PRODUCT CHANGE NOTICE

This PCN C0500 notice is to inform you of a label change for several items that you have purchased from Littelfuse.

Part numbers related to LFPCN.C0500

Figure 1: Current label vs New label

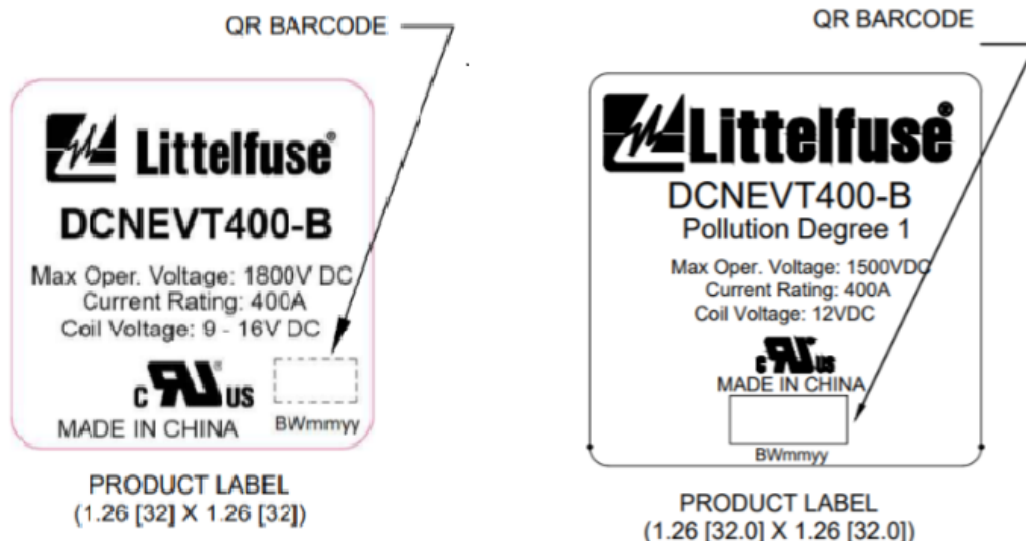
Littelfuse will be changing the information on the label utilized in the attached list of finished goods.

Compliance of UL requirements.
